Dear Reviewer #1,

Dear Reviewer #2,

Global Storm Tide Modeling with ADCIRC v55: Unstructured Mesh Design and Performance

Figure 6. Global M_2 $RMSE_t$ computed against the TPX09-Atlas for; (a) ADCIRC v54 on the Ref mesh, (b) ADCIRC v55 upgrade on the Ref mesh, and (c) ADCIRC v55 upgrade on the TLS-B mesh.

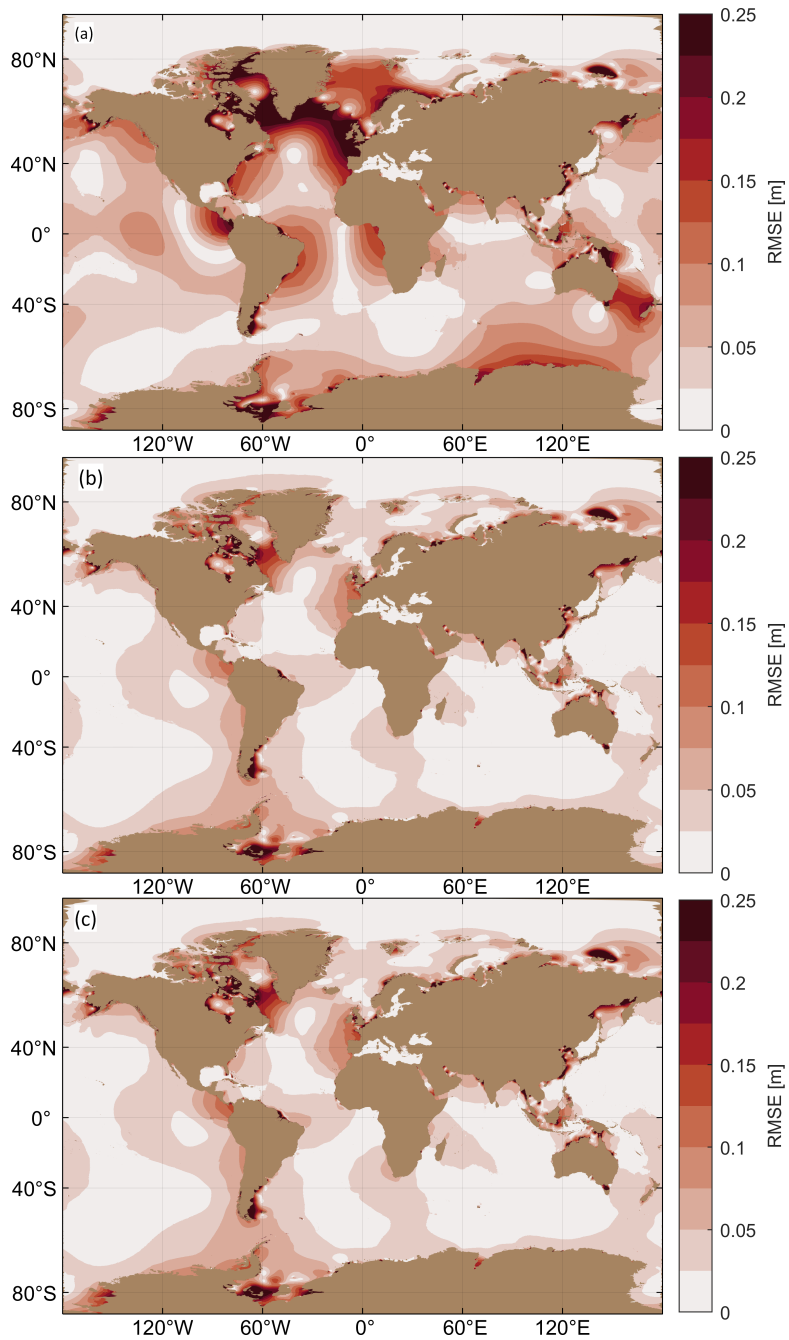
The “Discussion” section focuses on mesh configuration but does not explain the clear improvement between the two model versions on a same ref mesh (Fig. 6ab). Among the numerical improvements from v54 to v55, how does each of them contribute to the improved accuracy (mentioned in Section 3.1.1)? Which one is the main factor? Please add a few sentences or a paragraph to discuss this.

A: The reason for the improvement is due to the changes to the governing equations which is discussed in detail in supplementary Sect. S1.2. To summarize, the form of the equations (particularly the continuity equation) solved in the old version of ADCIRC did not correctly consider the curvature on the spherical Earth, so it was technically only valid for “small” domains.

C: We added a paragraph to the beginning of “Section 4: Discussion” to make this clear (Lines 345-351): [The new version of ADCIRC \(v55\) demonstrated improved tidal solutions compared to the previous versions of ADCIRC \(denoted as ADCIRC v54\). This is because ADCIRC v54 does not solve the correct form of the governing equations in Spherical coordinates and is thus technically valid only for sufficiently small regional domains \(see Sect. S1.2 for more details on this comparison\). For instance, this old form of the governing equations appears to be sufficient for the western North Atlantic Ocean regional domain, which has been thoroughly validated using ADCIRC since Westerink et al. \(1994\). The changes made in ADCIRC v55 make it suitable for simulating larger domains, in particular the global domains that we investigated in this study.](#)

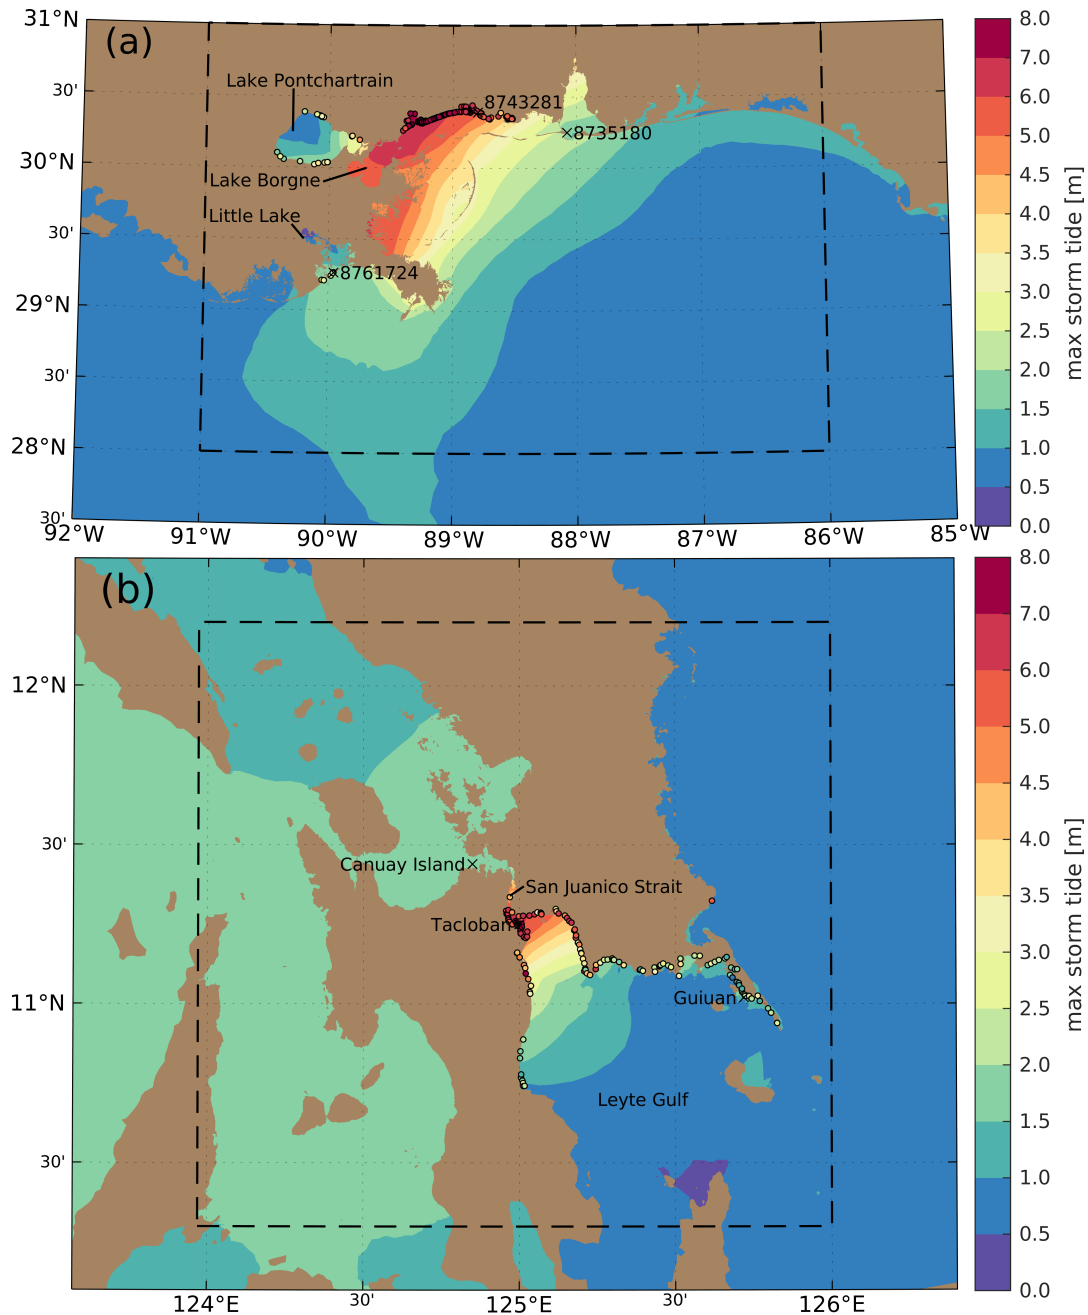
R: -L249: as shown by several studies (e.g. Townend and Pethick, 2002) and synthesized in Idier et al., (2019), representing flooding in storm surge models results in lower water levels seaward compared to simulations where the flooding is not represented.

Therefore, I expect that water levels in the present simulations are biased high due to this process, possibly by 0.5 to 1.0 m considering previous studies on the topic.

A: We agree with the point that you raised regarding that including inundation in the simulation would result in lower water levels seaward. In other words, the maximum coastal water levels shown in Figure 9 are likely biased high. However, here we are comparing to high water marks (HWM) measured on land using the closest modeled wet point. Runup onto the land can amplify the water levels beyond those recorded seaward, but since our simulated results at the coast are likely biased high there is a degree of cancellation involved. Nevertheless, we noted that our closest wet point results might only follow the lower envelope of HWMs as noted by Mori et al. (2014) since the amplification could be greater than the low bias due to not simulating inundation especially in the presence of steep topography.

C: Added to the end of Lines 267-268 (old L249): ... (although ignoring inundation in our simulations is expected to overestimate the seaward maximum storm tide heights (Idier et al., 2019) that likely cancels out some of the otherwise low bias when compared to HWMs).

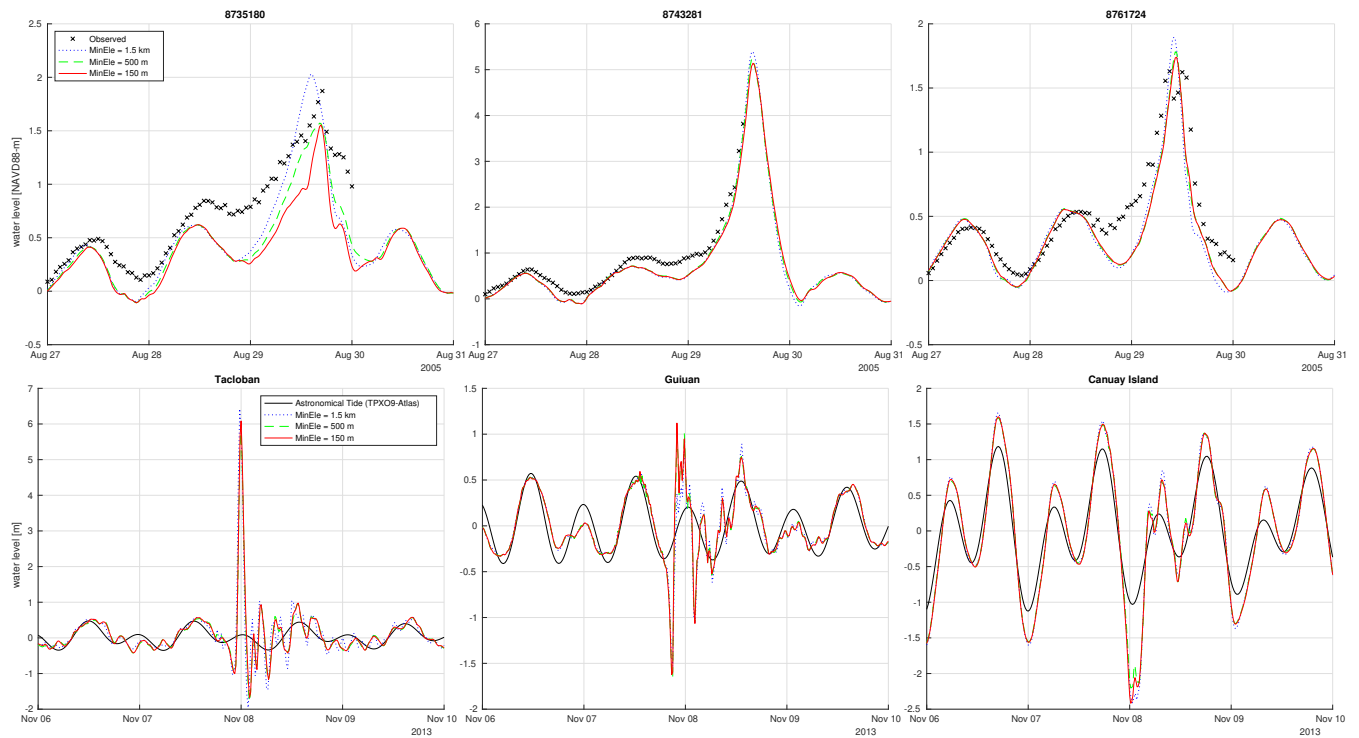
R: -Figure 11: for Katrina, the model displays a 0.5 m negative bias before the surge peak, could the authors comment on the possible causes? Could it be related to the 2DH approach which only allows for a crude representation of Ekman transport?

A: On lines 261-264 of the original manuscript we noted that this negative bias could have been due to the neglect of the regional wave setup since a previous ADCIRC-based study that coupled to short waves better matched the time series before the surge peak (Roberts and Cobell, 2017). However, after subsequent simulations by our group on separate but related research, we do not think that this bias is mostly attributable to the insufficient generation of the surge forerunner (e.g., Kennedy et al., 2011). This fact indeed arises from the crude representation of Ekman transport by the 2DH approach as the reviewer surmises, but the negative effect can be mitigated by setting the bottom friction coefficient to a very small value on the shelf. The previous studies by Bunya et al. (2010) and Roberts and Cobell (2017) used a Manning's formulation for the bottom friction coefficient (where $n \sim 0.02$ in the ocean) which leads to very small values of the C_f on the continental shelf (~ 50 -200 m deep).

C: Changed the old lines 261-264 to the following (new Lines 283-289): [We think that this negative bias is mostly attributable to the insufficient generation of the surge forerunner and partly also to the omission of regional wave setup. The surge forerunner is generated through the Ekman setup process \(Kennedy et al., 2011\) which is crudely represented by the depth-averaged model used here. Previous depth-averaged ADCIRC-based studies that used a Manning's bottom friction formulation so that \$C_f\$ becomes very small on the continental shelf appear to be better able to generate the surge forerunner, as well as employing wind wave-coupling that generates wave setup, indeed show better agreement with the time series prior to the peak storm tide \(Bunya et al., 2010; Roberts and Cobell, 2017\).](#)
